REMARKS

Amendments to the Drawings:

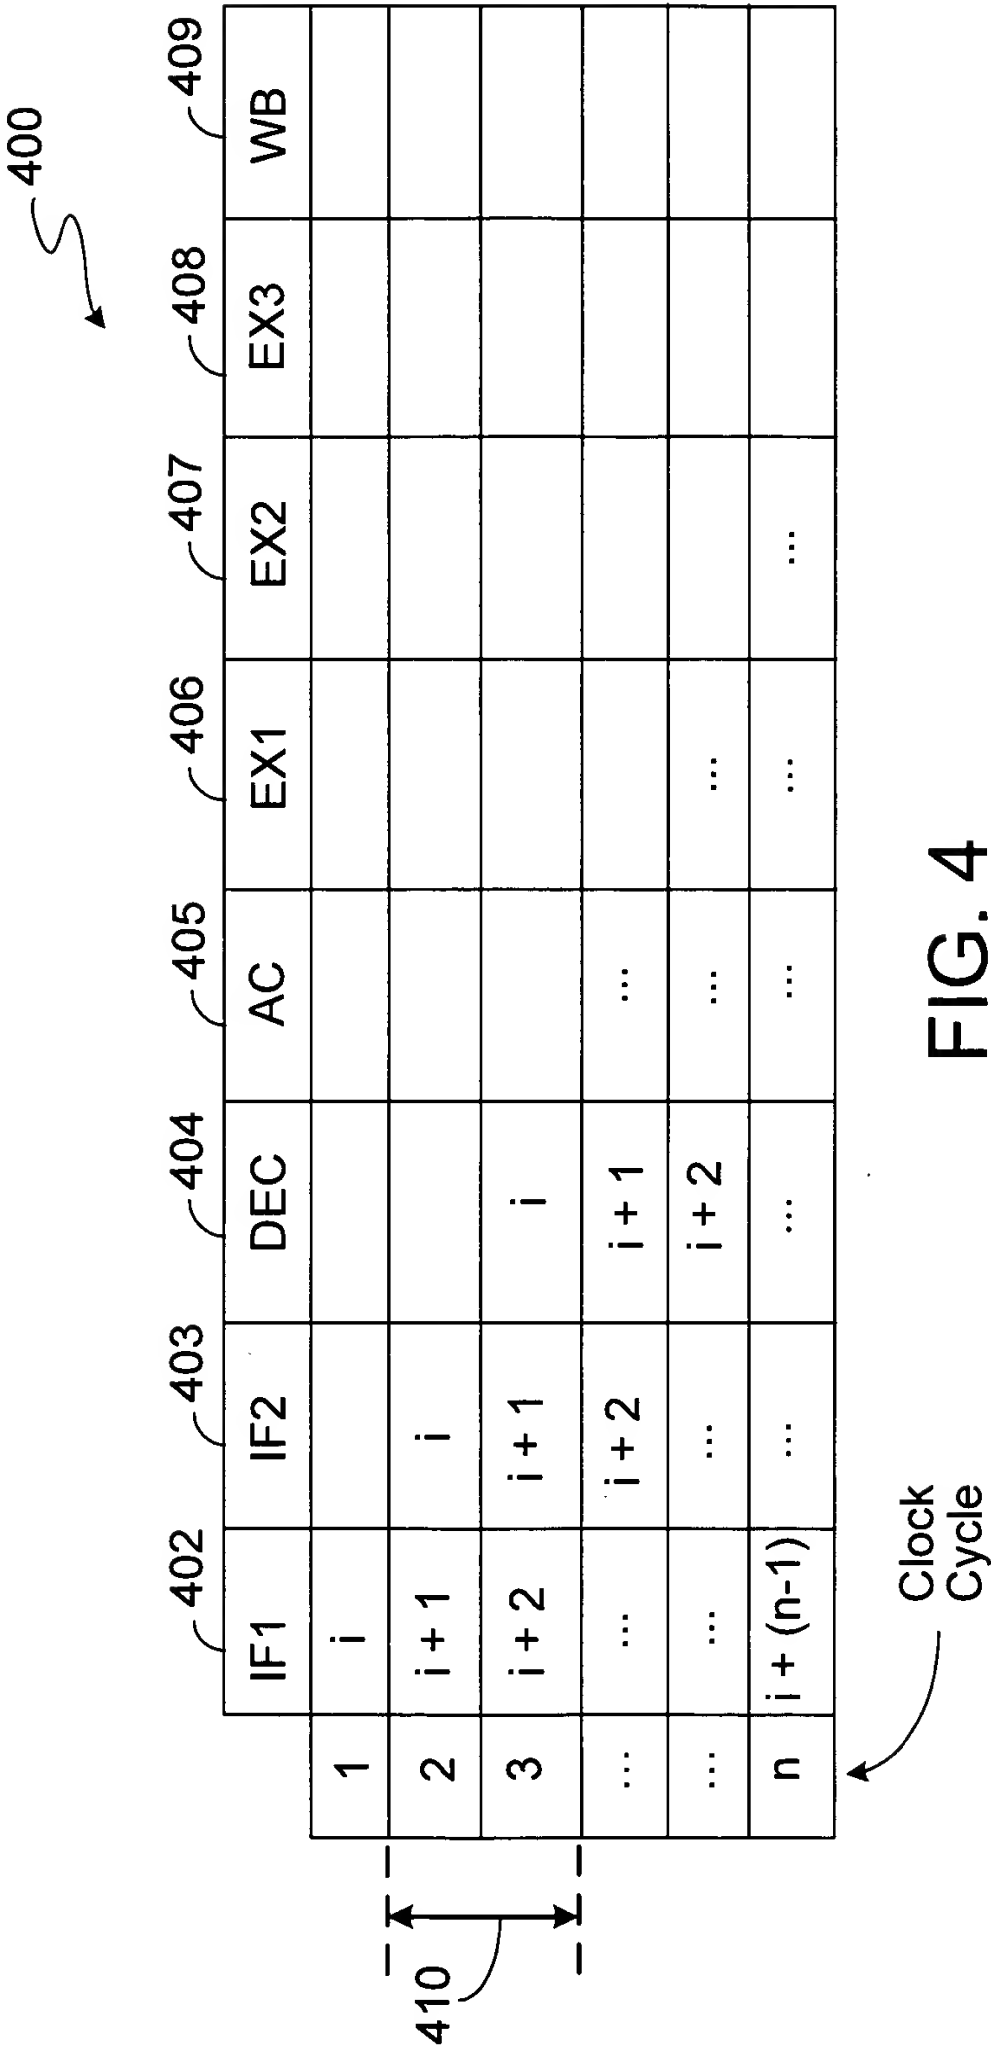
Figure 4, has been amended to show a cache latency of 2 cycles (labeled as 410) to illustrate the example of looking ahead by 2 cycles described in the specification.

FIG. 5

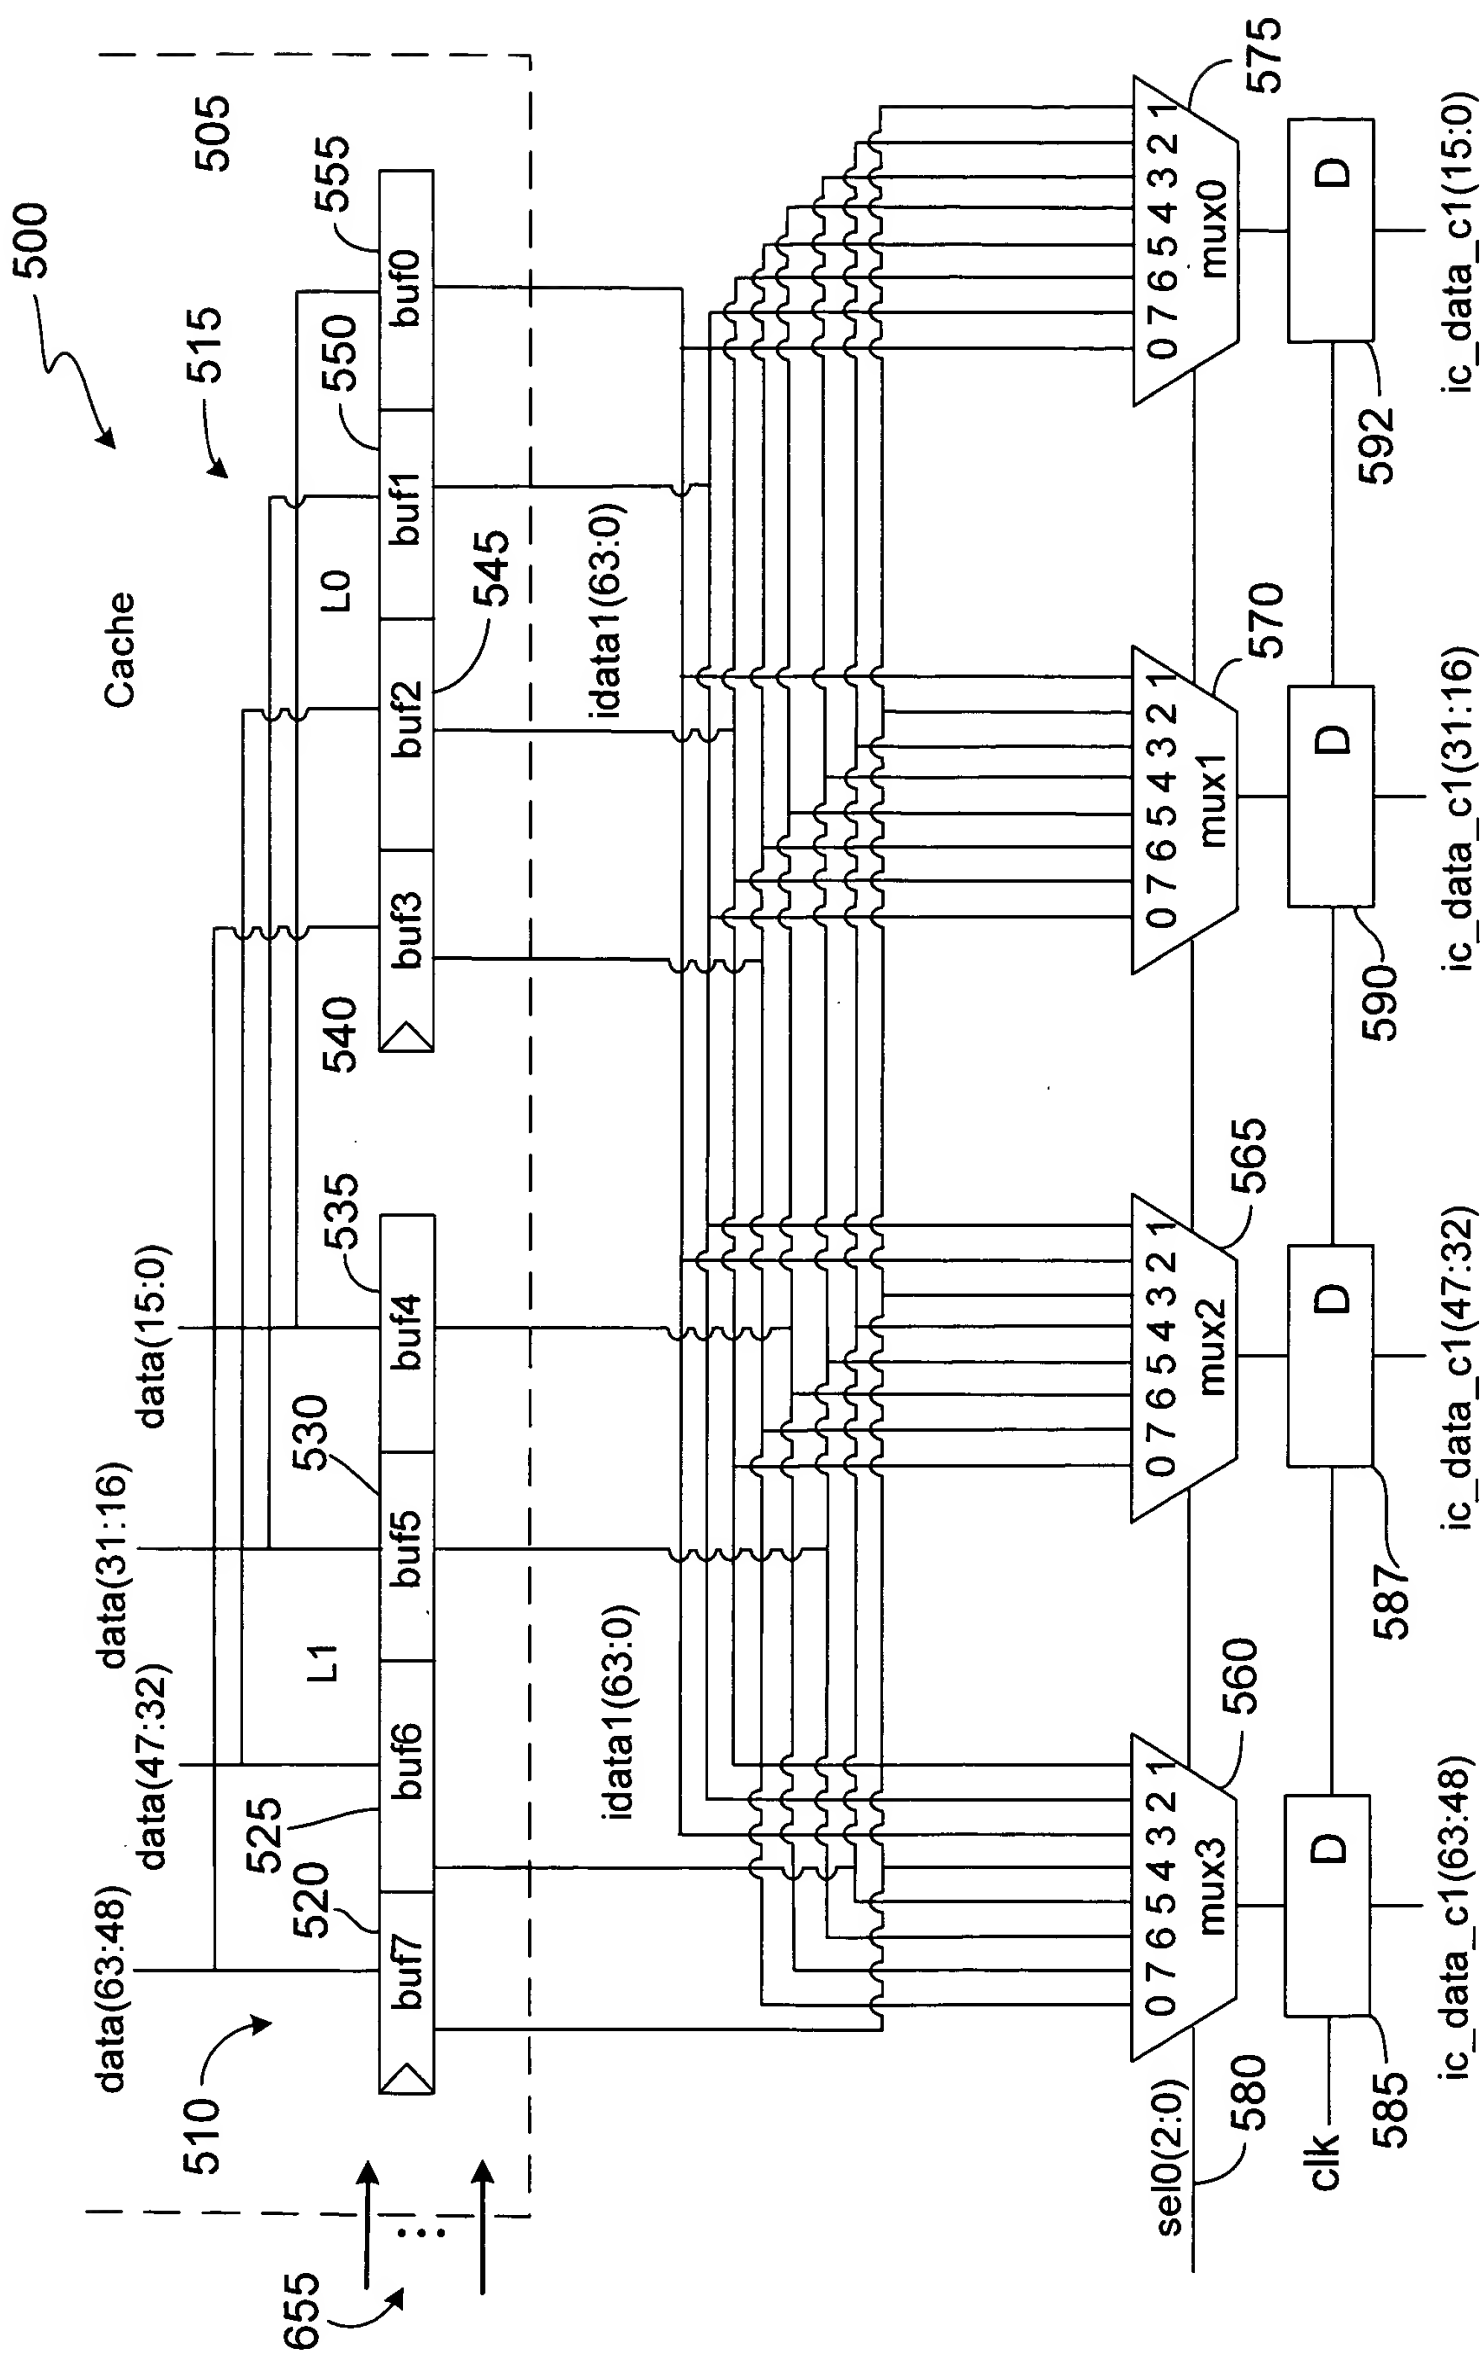
Figures 5 and 6, have been amended to explicitly show pointer signal lines (labeled as 655) used by the transition block 645 to determine the values of the pointers to the buffers 520-555.

FIG. 6

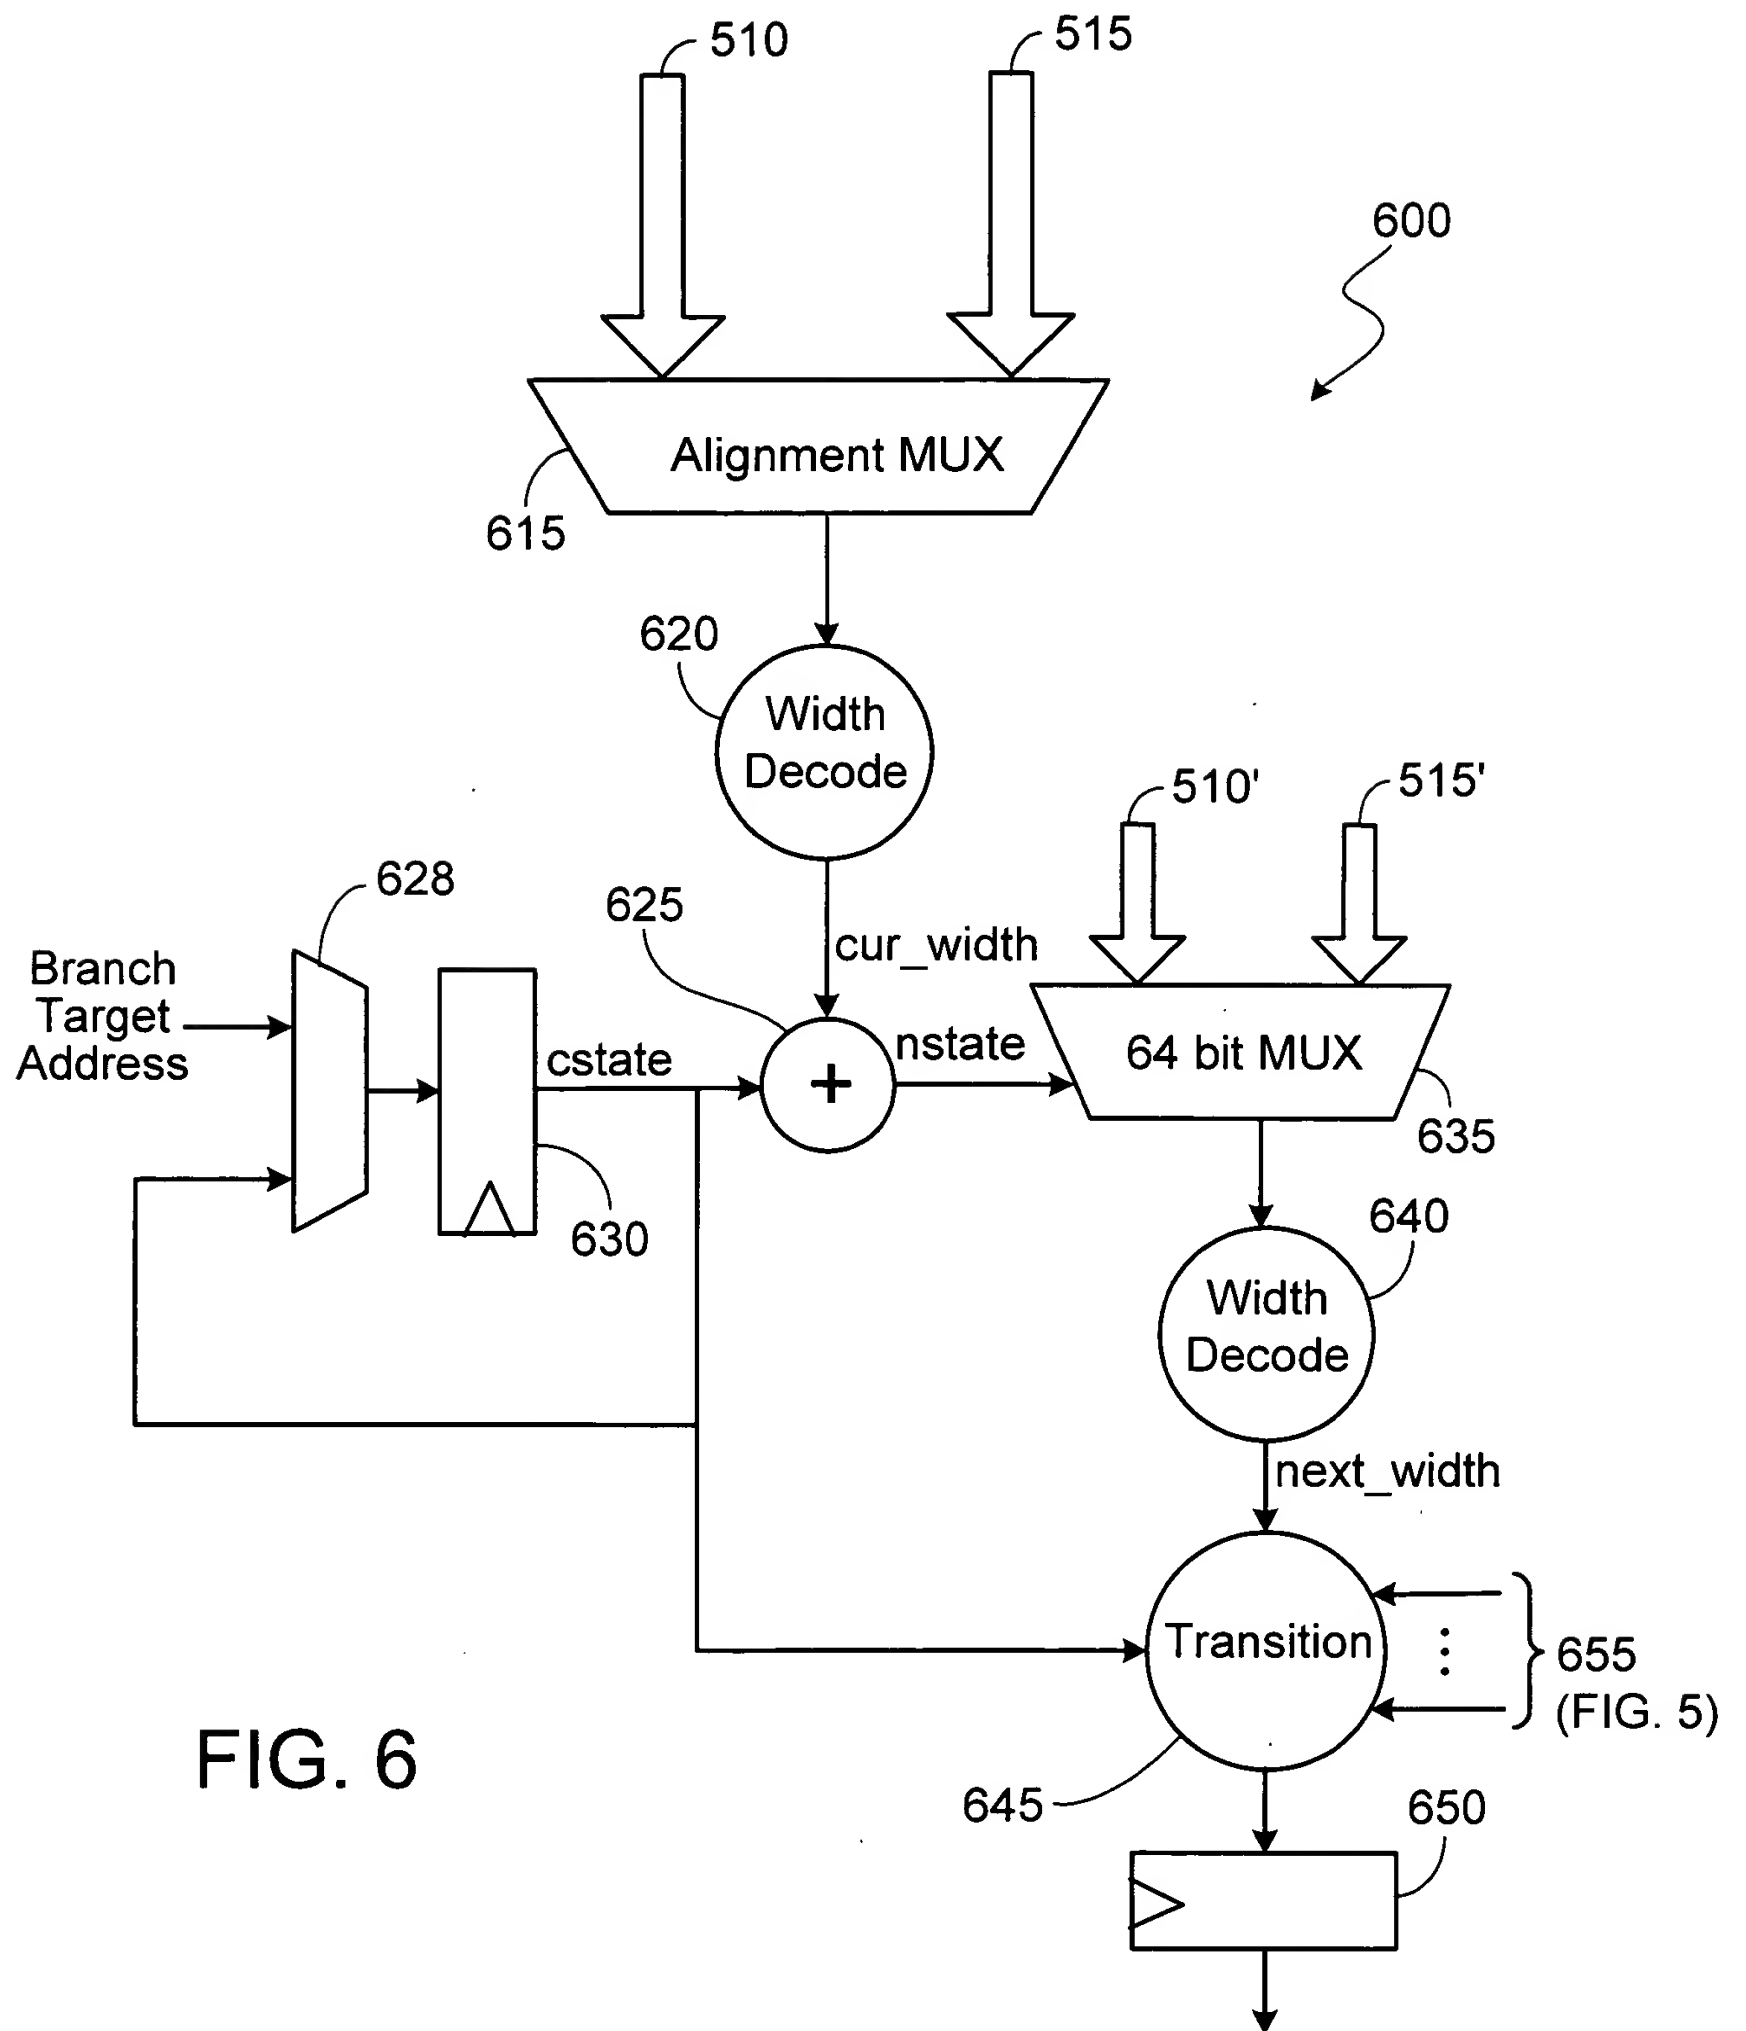
A typographical error in Figure 6 has also been corrected to conform Figure 6 to the description on page 13, lines 3-4 by changing reference numbers 505' and 510' to reference numbers 510' and 515'.
